## ENGINEERING CHANGE NOTICE

1. ECN ~~XXXXXX~~Proj.  
ECN B-714-150

### 1) H-2-77596 Sh 1, Rev 1

### 2) H-2-77630 Sh 1, Rev 0

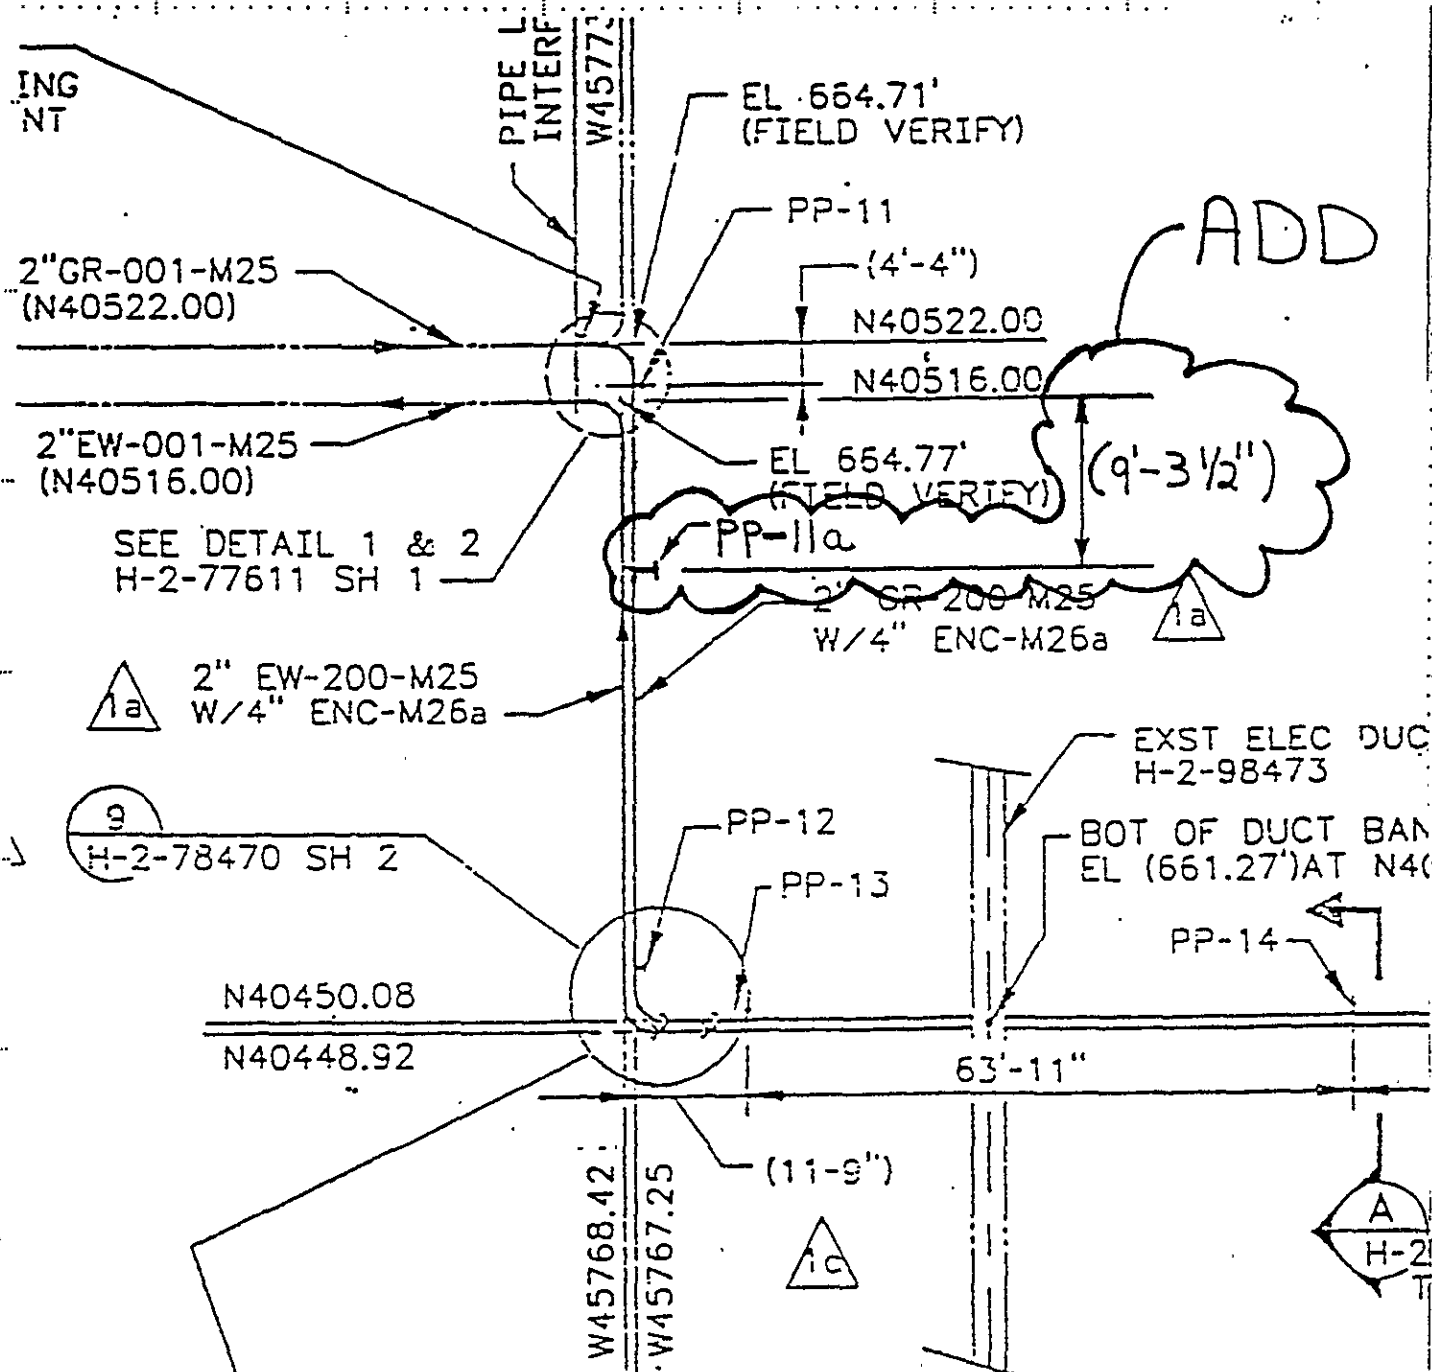
PLAN (Z D7): Modify as shown on page 5 of this ECN.

**SENSING CABLE  
ARRANGEMENT PLAN**  
SEE DRAWINGS H-2-77596 &  
H-2-78467 FOR PIPING PLANS

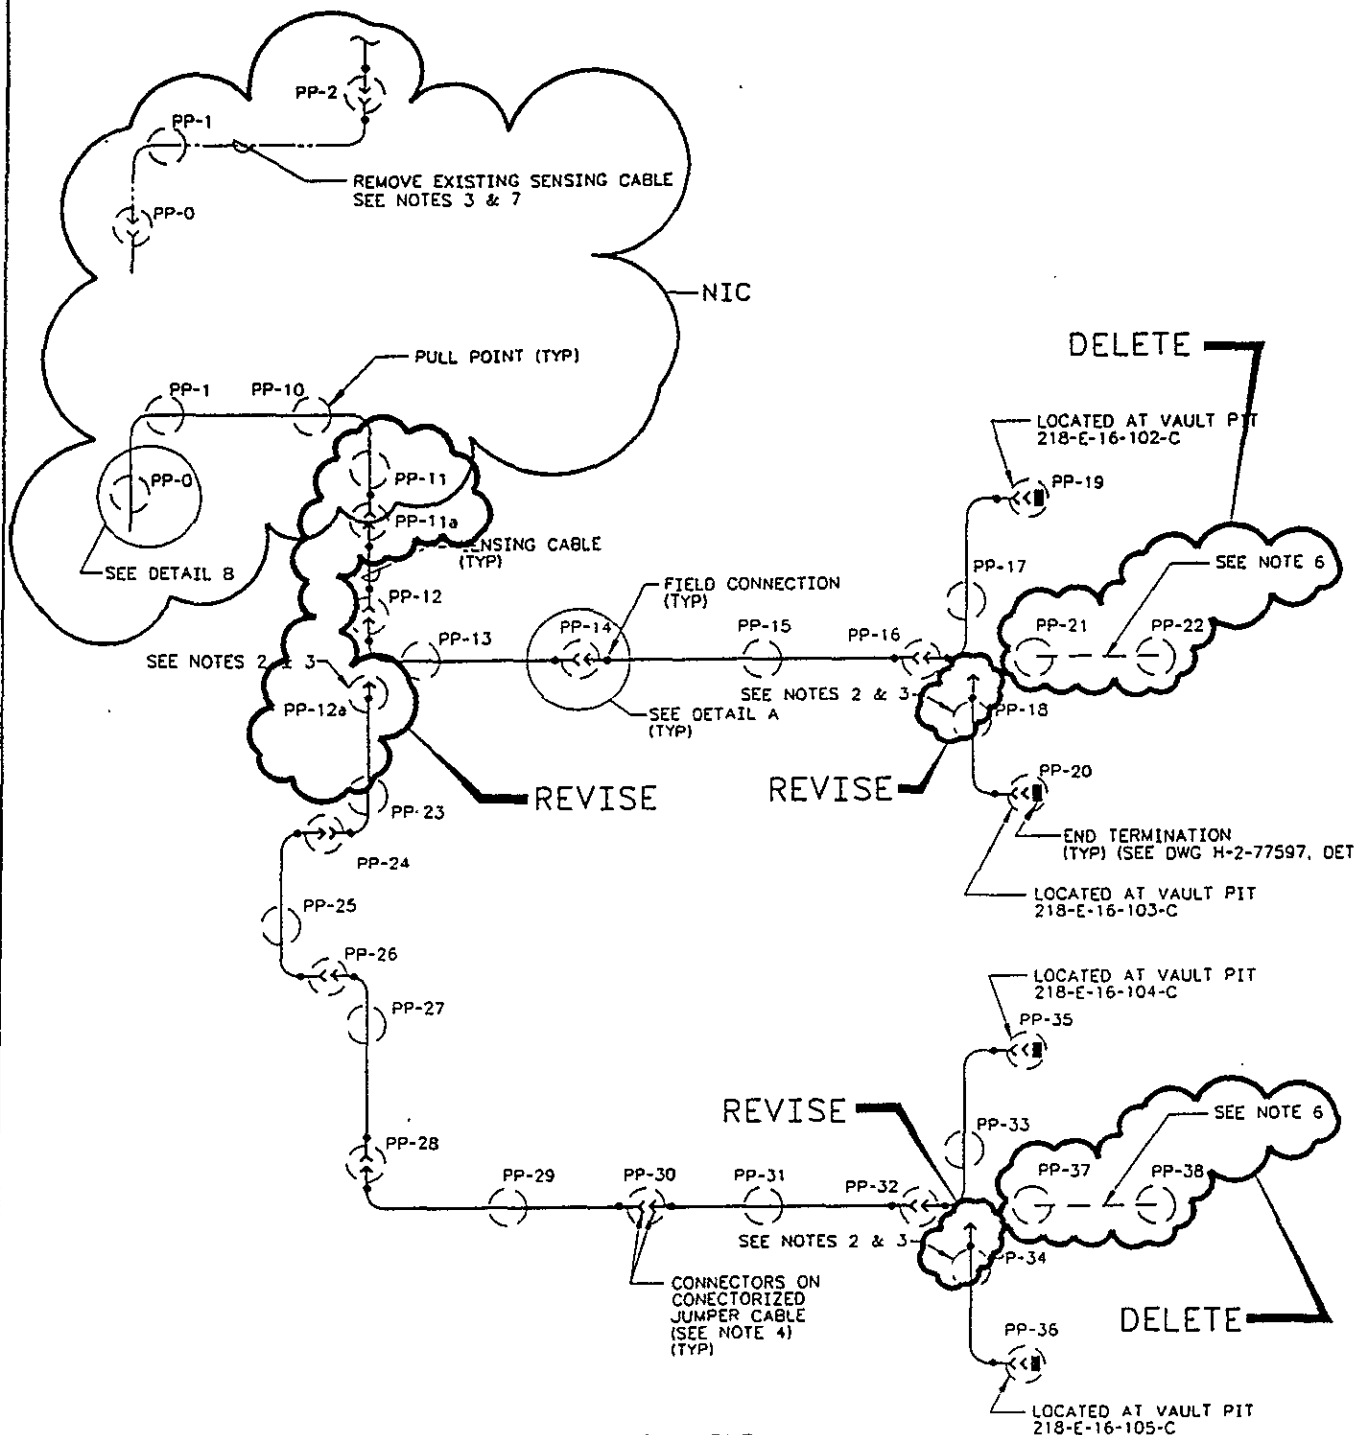
(FC-Items 1 & 2A, B, & D): To provide more space for coiling the sensing cable.

A) Revise Sensing Cable Arrangement Plan as shown on page 6 of this ECN.
